TO: Programs, Projects, and Operations Subcommittee
FROM: Eric Williams, Natural Resources Planner
SUBJECT: Hell Creek Grade Control Stabilization, Change Order 1
DATE: August 5, 2016

CHANGEDATE AUGUST 4, 2016**ORDER**OWNER PAPIO-MISSOURI RIVER NRDHELL CREEK GRADE CONTROL
STABILIZATION (AT CONFLUENCE WITH
PROJECT WEST PAPILLION CREEK)JOB NO. 115048-01CHANGE ORDER NO. 1CONTRACTOR: VALLEY CORPORATION
28001 IDA CIRCLE
VALLEY, NEBRASKA 68064

REVISION TO THE CONTRACT BID ITEM

As Constructed	Hell Creek Grade Control Stabilization		Project No./Code
No Revisions:	(at Confluence with West Papillion Creek)		15048-01
Revised:	Designer:	DGL	Structure
Void:	Detailer:	LEK	Numbers
	Subset:		Sheets: 8 of 14
			Sheet Number 8

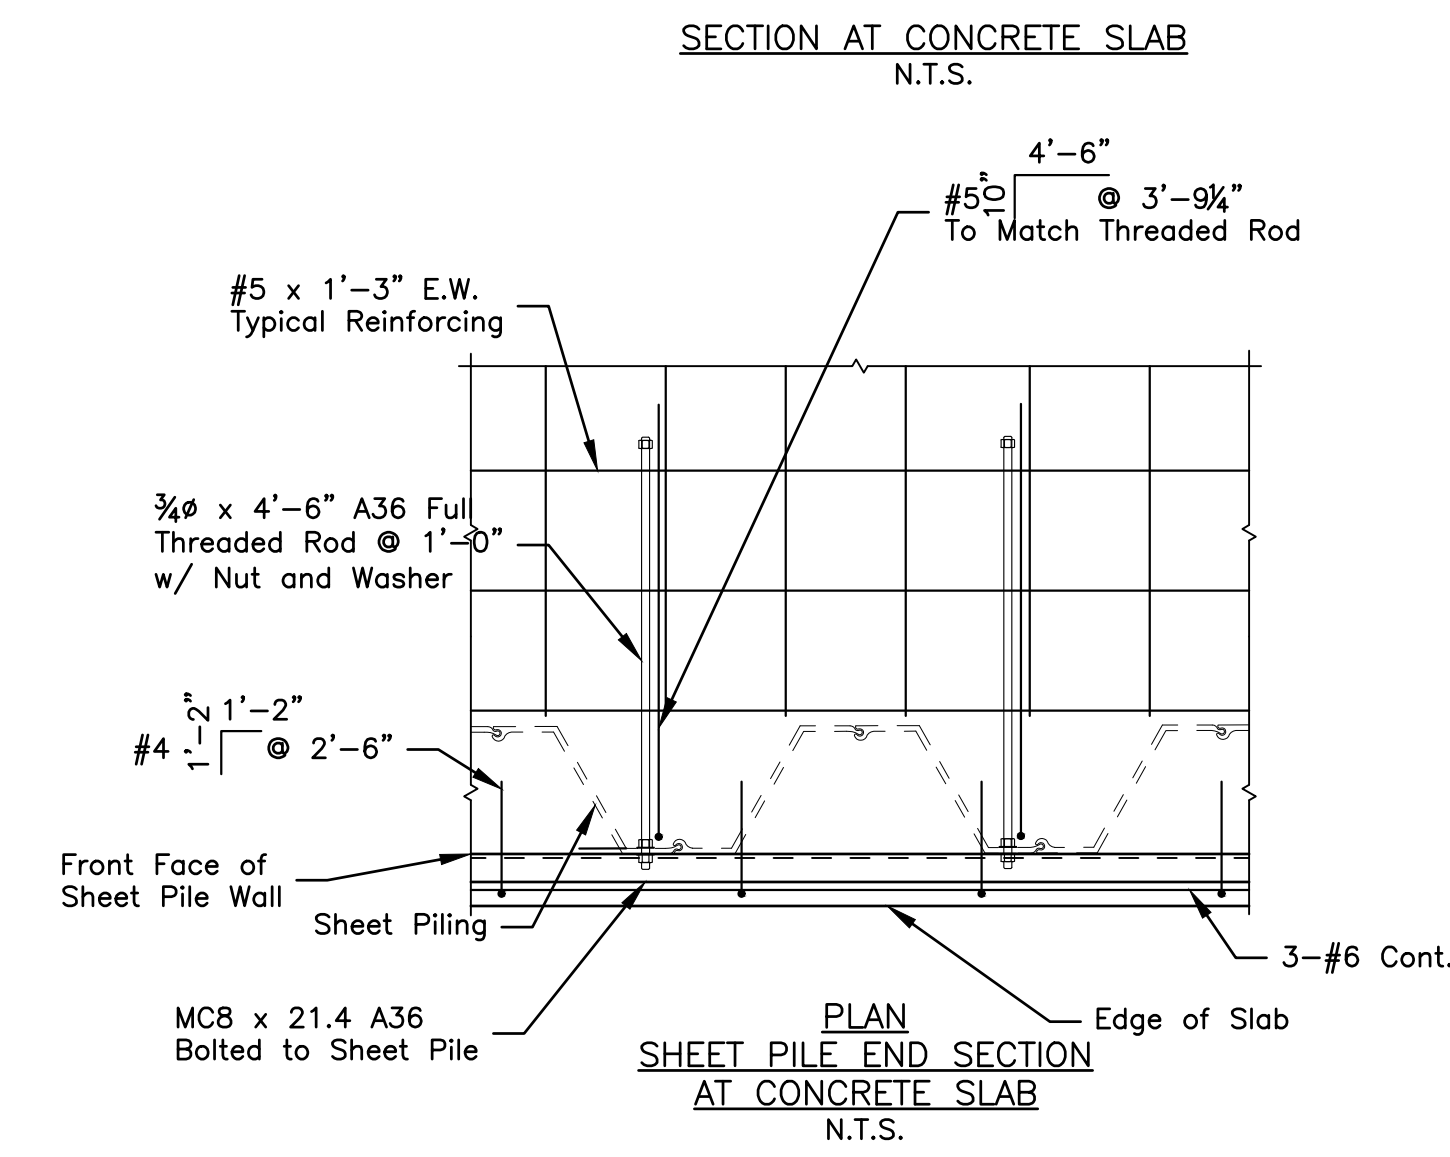
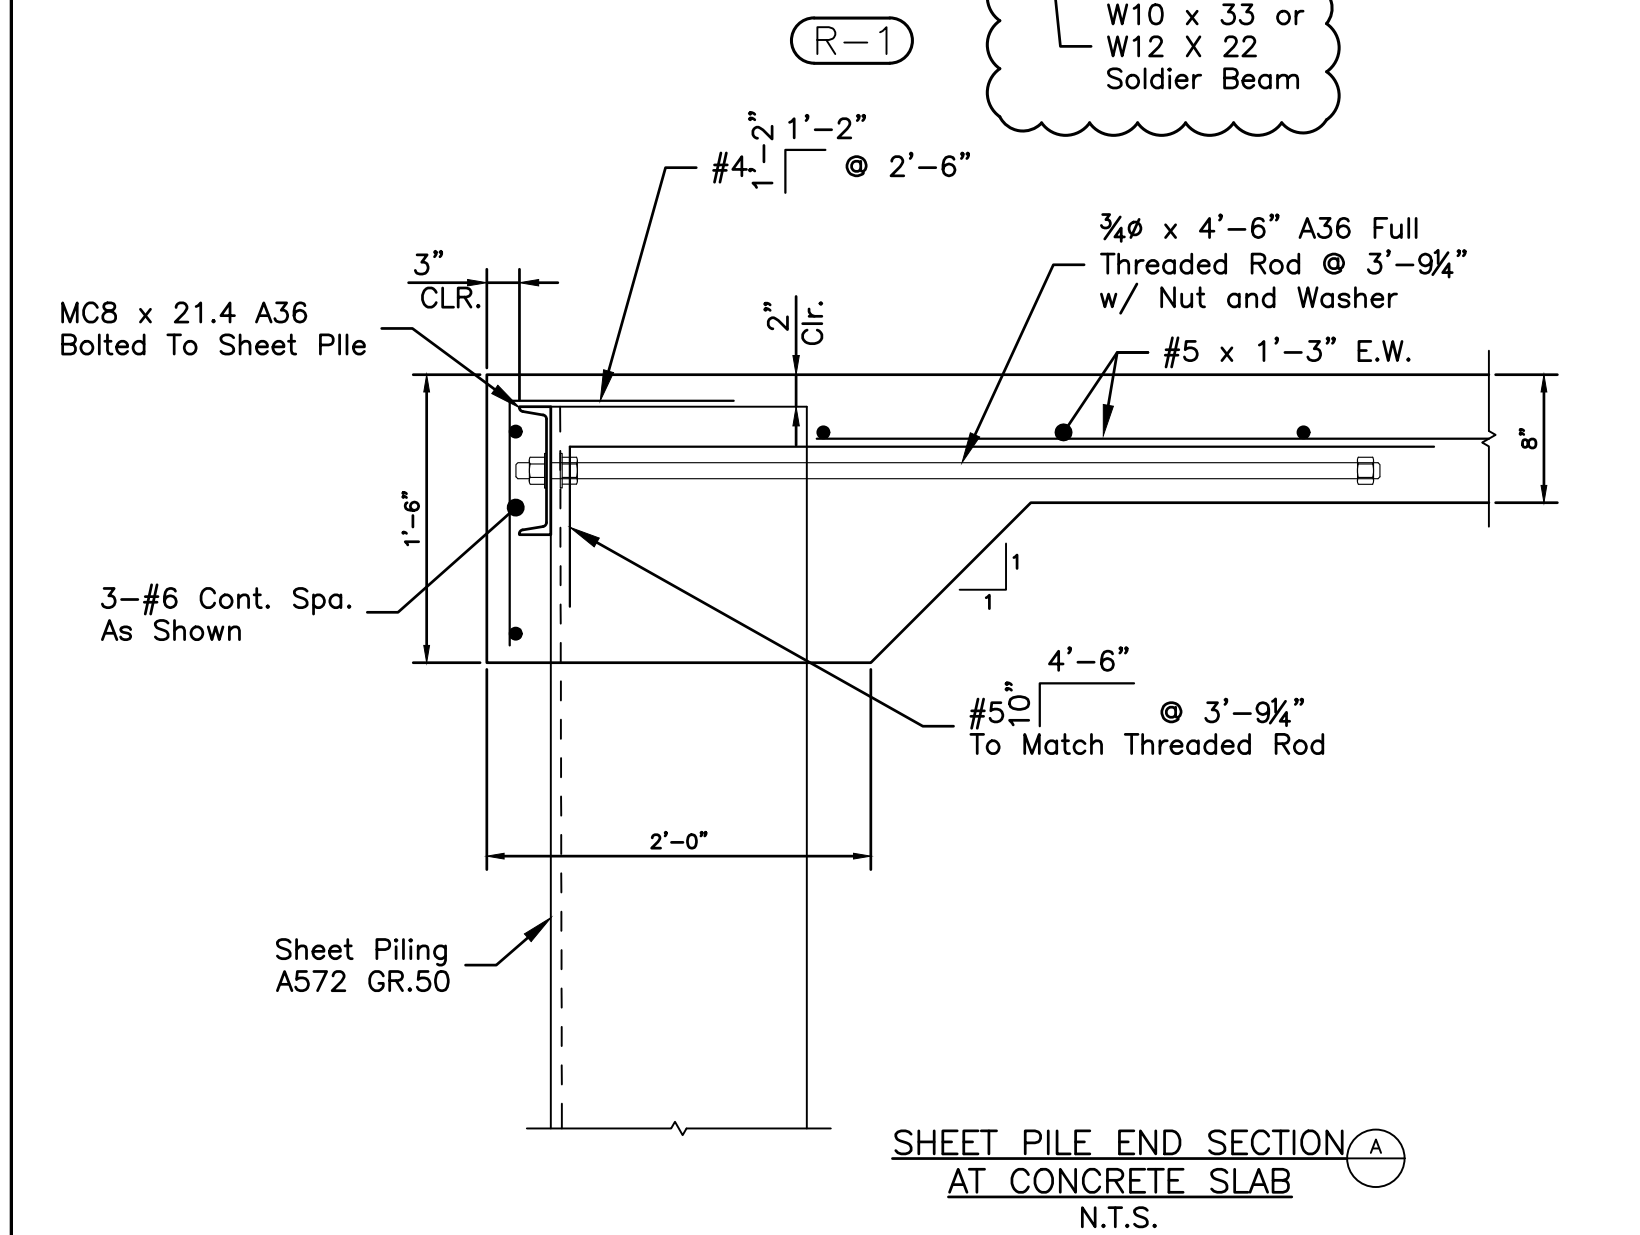
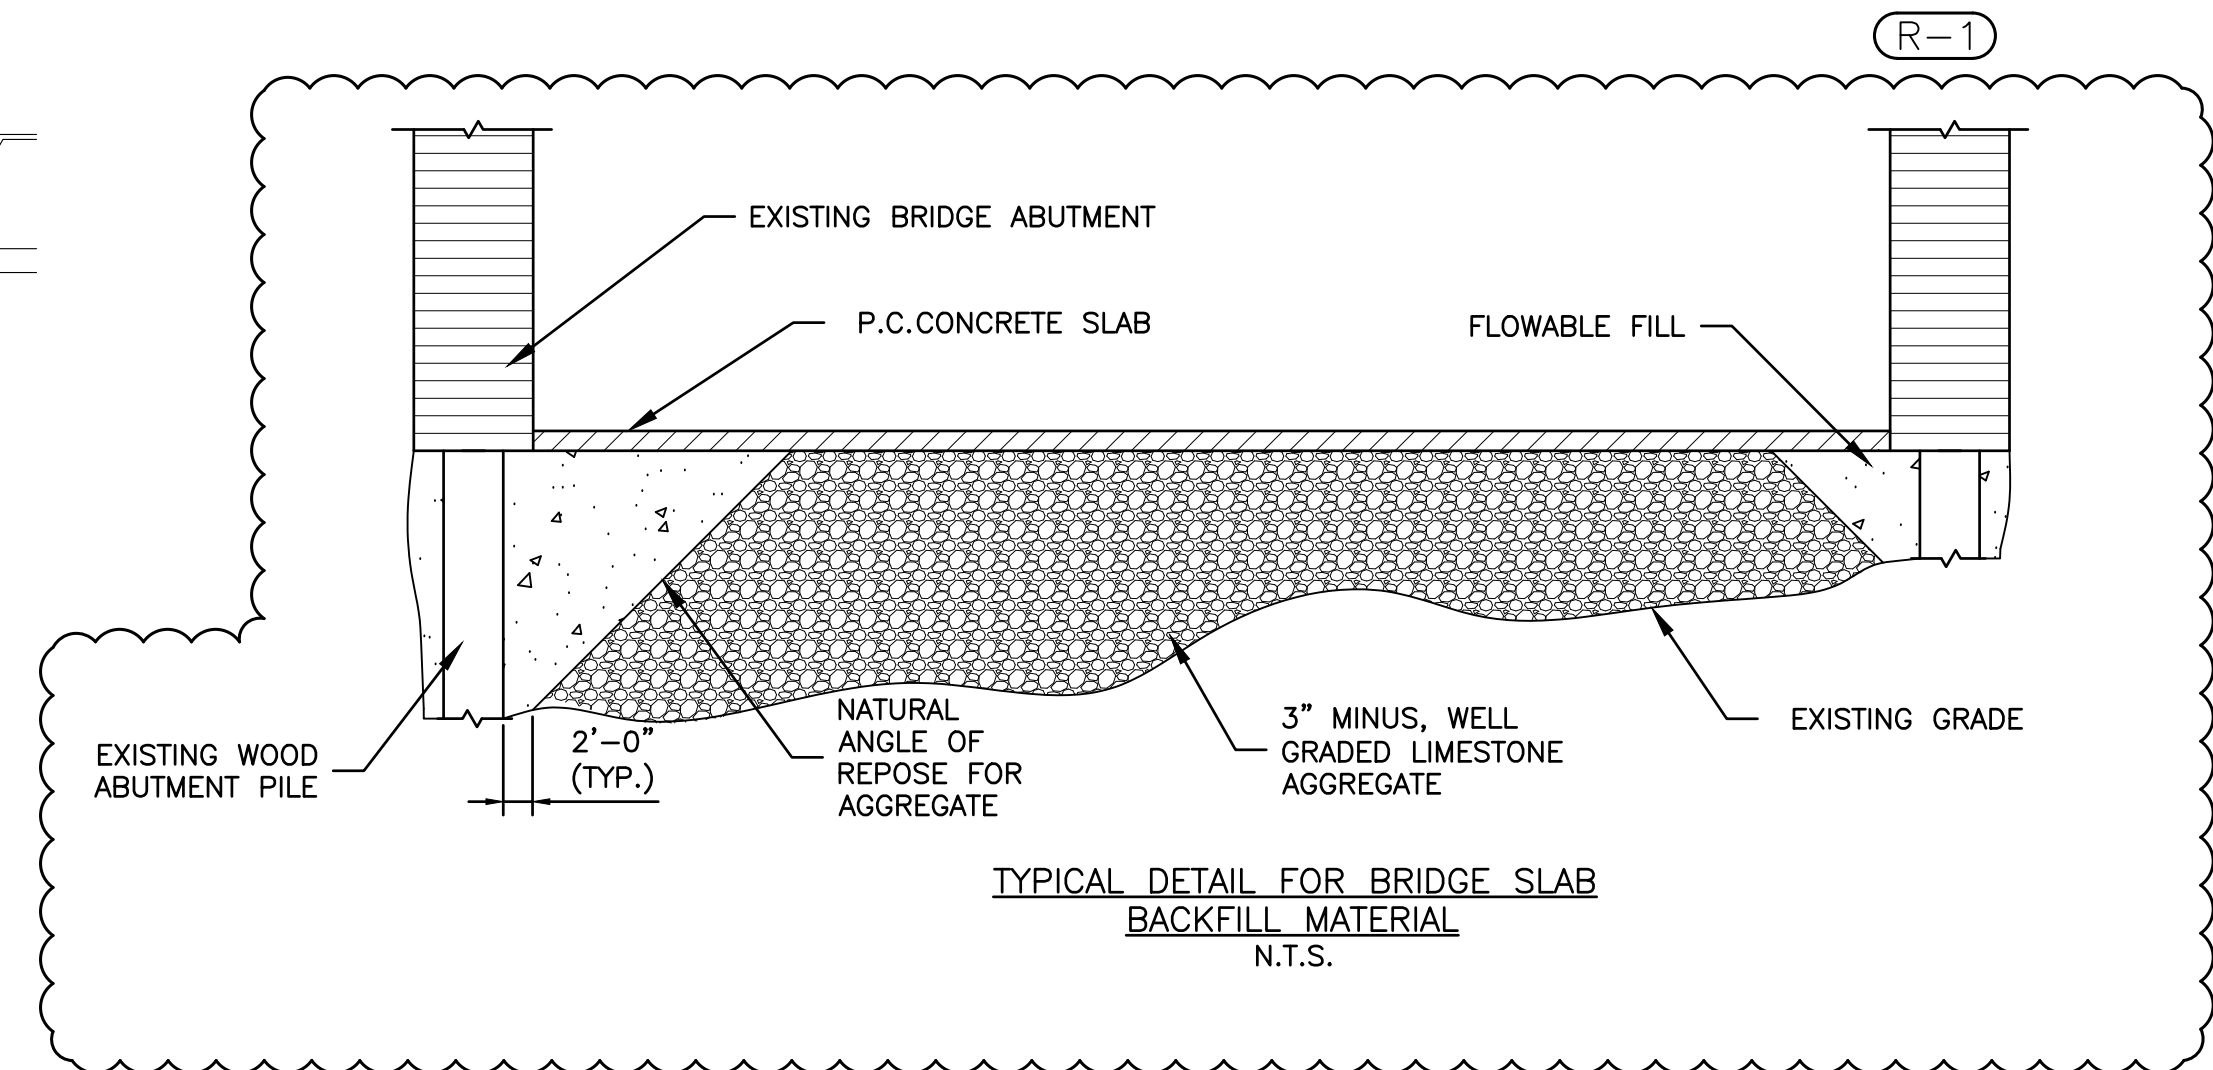
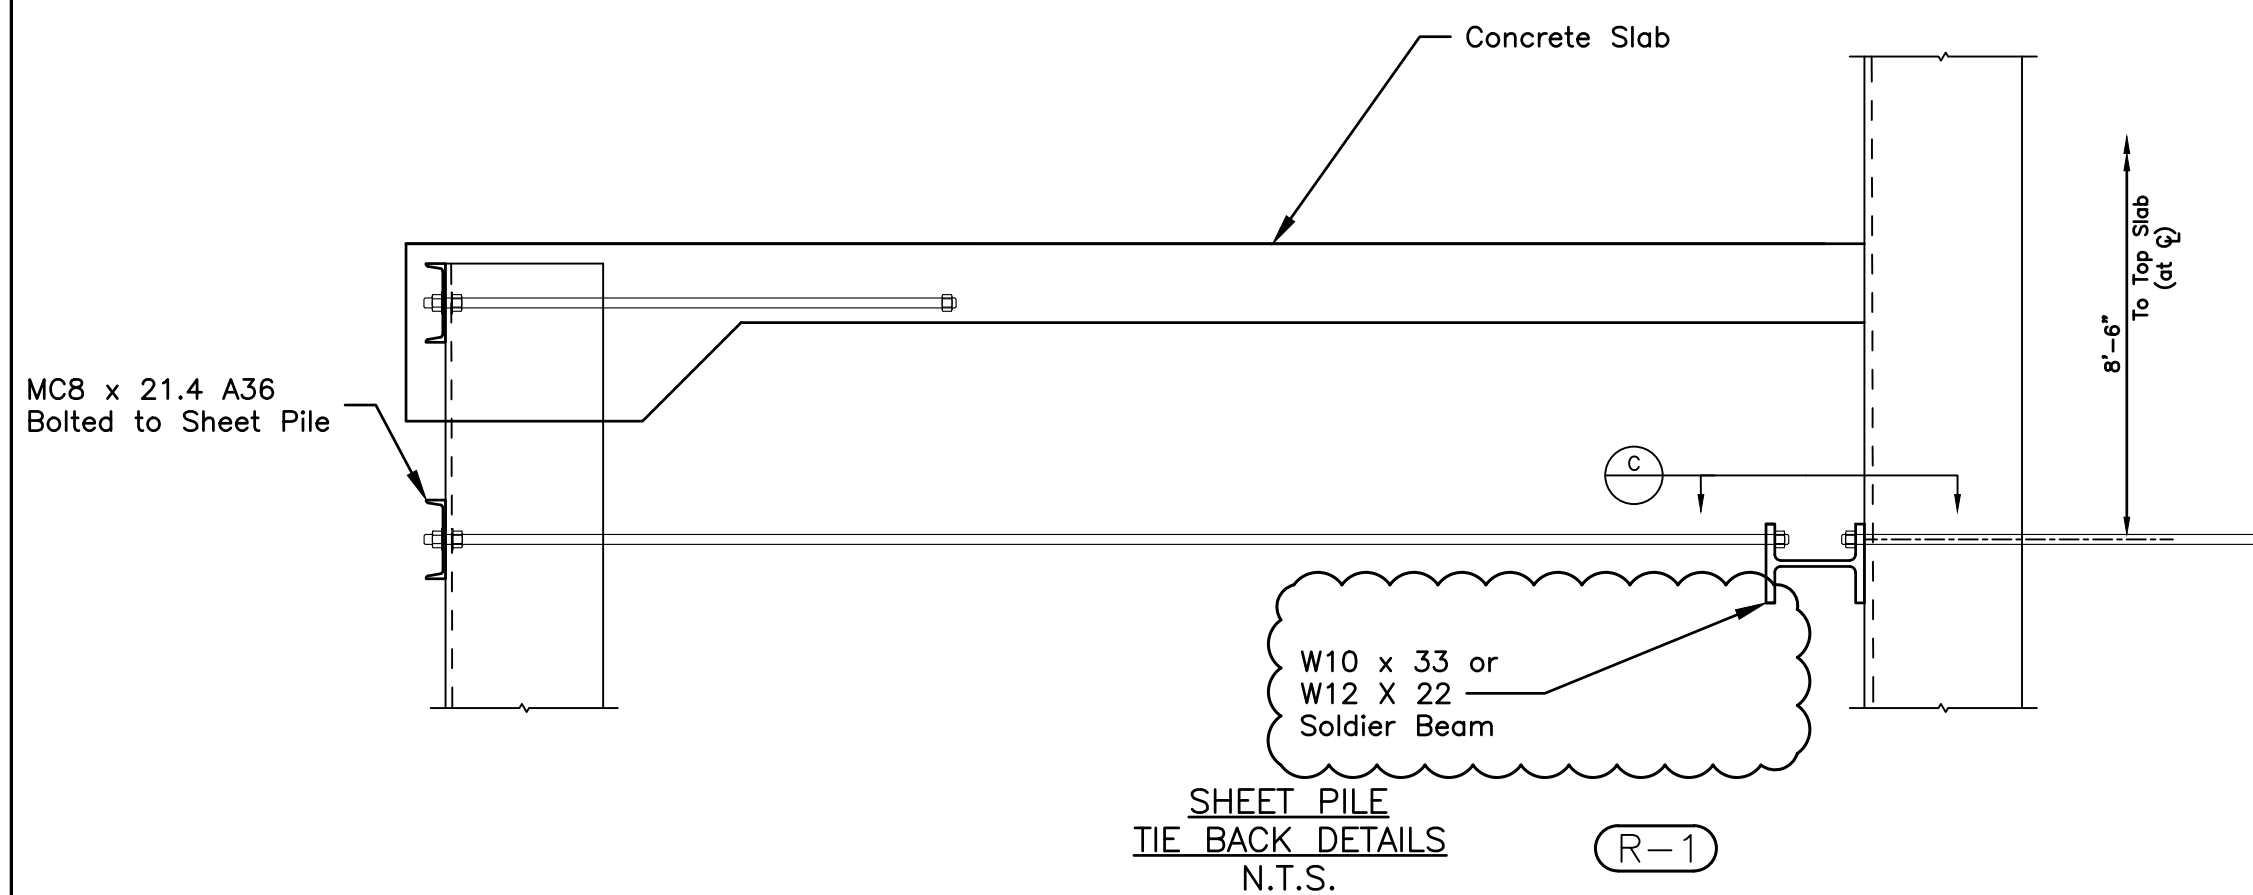
General Notes and Tabulations (Sheet 2 of 14)
Site Plan and Profile (Sheet 5 of 14)
Bridge Structure, Other Details (Sheet 8 of 14)

17. TIE-BACK SYSTEM CORROSION PROTECTION: The contractor shall apply corrosion protection to the tie back system as noted in the PLANS. Payment at the contract lump sum for "Tie-Back System Corrosion Protection" shall be full compensation for furnishing all labor, materials, equipment, tools and incidentals necessary to complete the work.

1. Tie-backs shall have a capacity of 56 kips each. At the contractor's option, tie-backs may be connected to the upstream sheet pile. alternately, an intermediate dead-man anchor block may be installed, or other mechanical means as approved by the engineer.

5. All steel components of the tie-back system not embedded in concrete shall be hot-dip galvanized to a minimum zinc coating thickness of 6.0 mils. Galvanization shall take place after fabrication prior to erection. Inspect galvanization after erection and touch up with galvanizing spray as required. This includes but is not limited to anchor rods, soldier beams, walers, and tie-back connections.

6. After installation, exposed anchorage components shall be coated with coal tar epoxy.
